# DRESDEN NUCLEAR POWER STATION UNIT 2

SUPPLEMENT NO. 1 FOR

## TOPICAL REPORT TO DPR-19 MODIFICATION 71-1 REFUELING

TOPICAL REPORT TO DPR - 19

FIGURE 1  
IRASDEN TYPE V PERFORMANCE

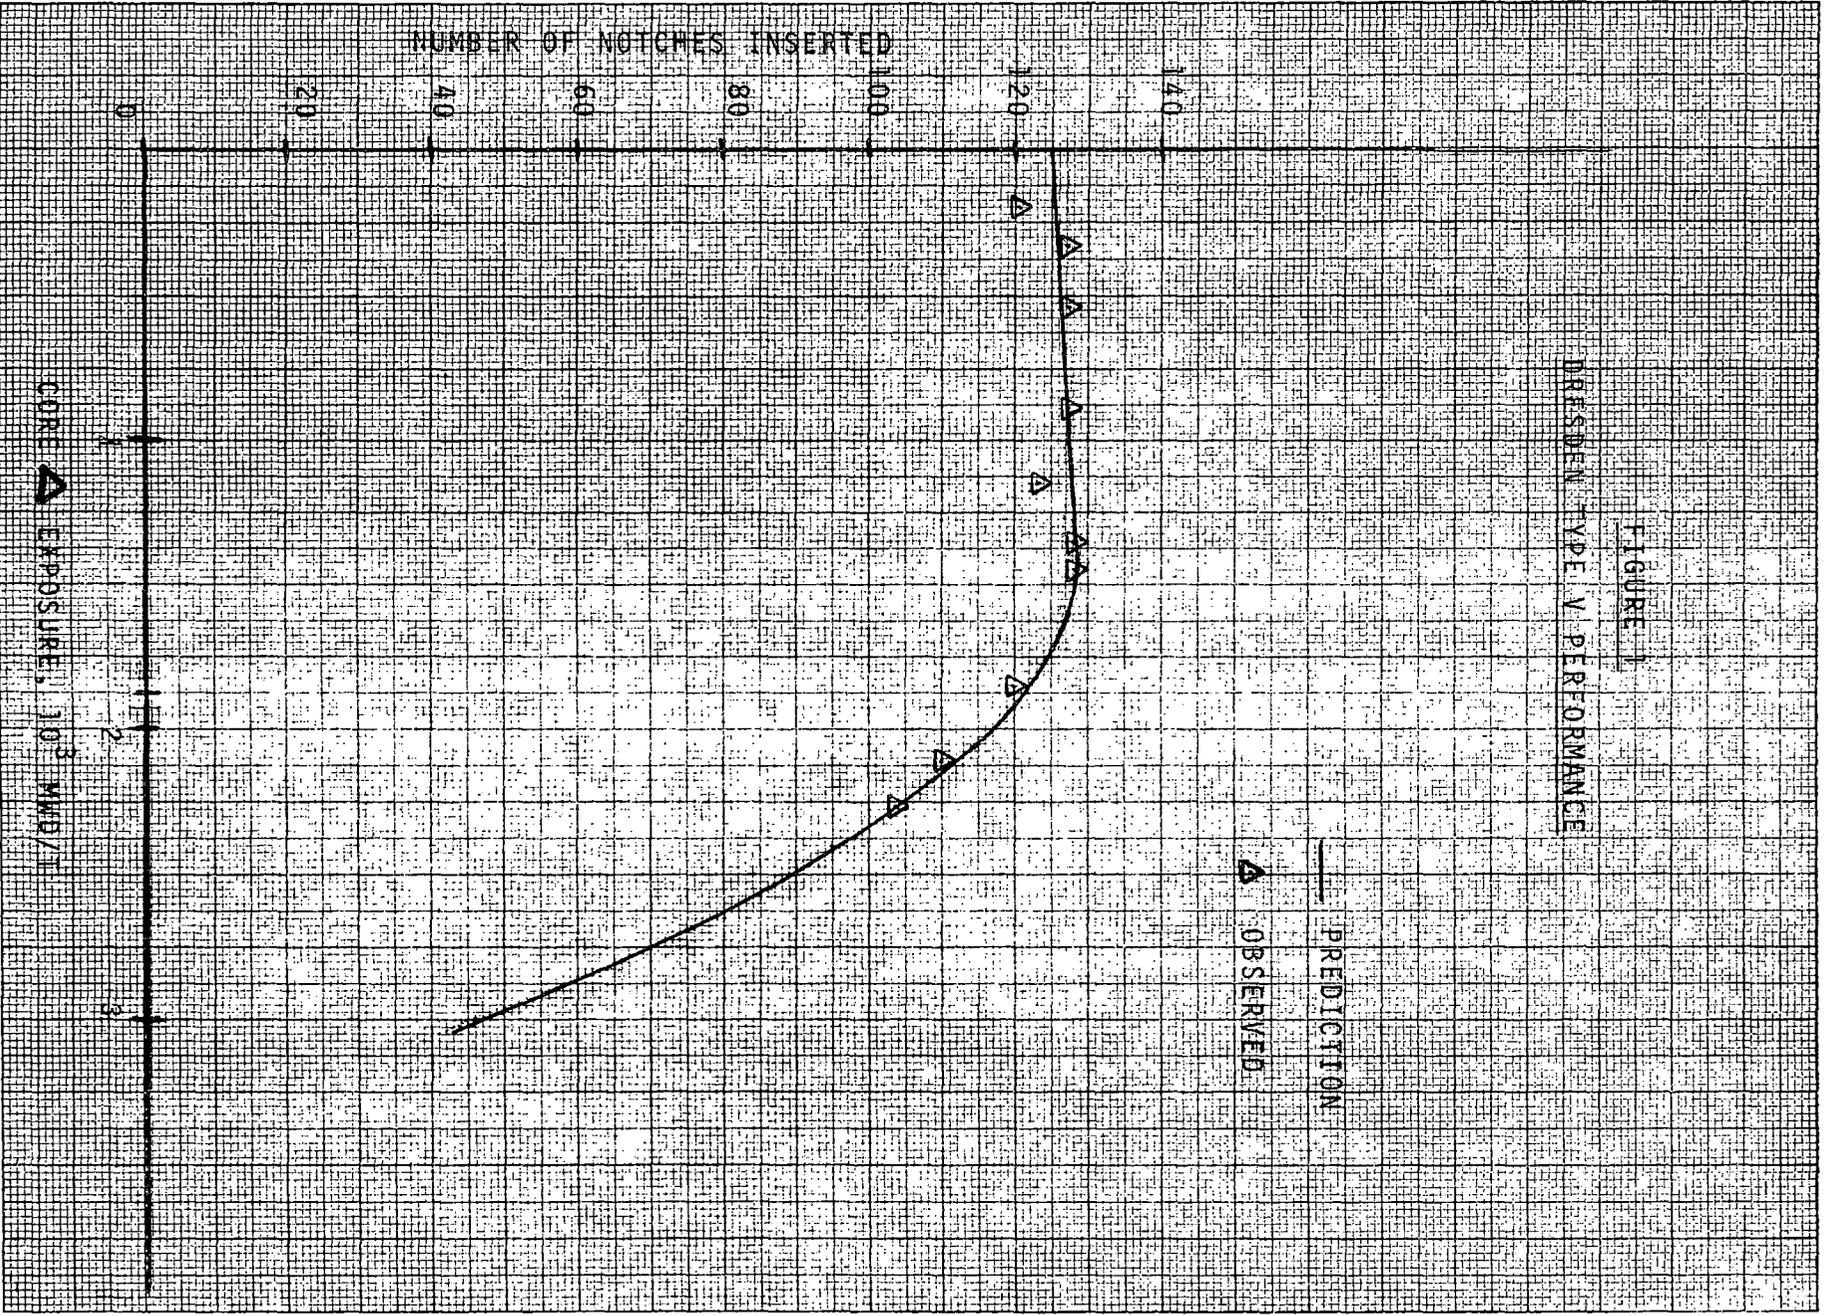
Separately describe your program for the  $Gd_2O_3-UO_2$  fuel. Discuss how previous observations of  $Gd_2O_3-UO_2$  burn-out in other General Electric BWR's were used to make estimates of the burn-out rates in the Quad-Cities Station. Indicate how your surveillance program will verify predicted burn-out performance.

As discussed in section 4 of Amendment 9, the nuclear methods used on the  $Gd_2O_3-UO_2$  rods in Quad-Cities fuel assemblies is the same basic method used on the gadolinia-bearing fuel rods in the Type V Dresden reload. The Type V minimum critical and the cycle operation of the Dresden 2 reactor were very close to prediction. The Dresden 1 cycle five operation is further amplified in Figure 1. Inspection of the figure shows that the predicted and observed control rod insertion are in close agreement. This plant data and similar plant data from Humboldt Unit 3 have served to verify that the predicted gadolinium burn-out is correctly matching the fuel depletion. The surveillance program includes the prediction of hot operating control rod patterns. As delineated in Section 3.3 of the D-2 Technical Specification and in the proposed Quad-Cities Technical Specification (Amendment 11), the actual and expected control rod configurations shall not differ by an amount exceeding 1%  $\Delta$  k. This reactivity comparison at specified frequency assumes the timely identification of any anomaly and a reactor shutdown for thorough evaluation.
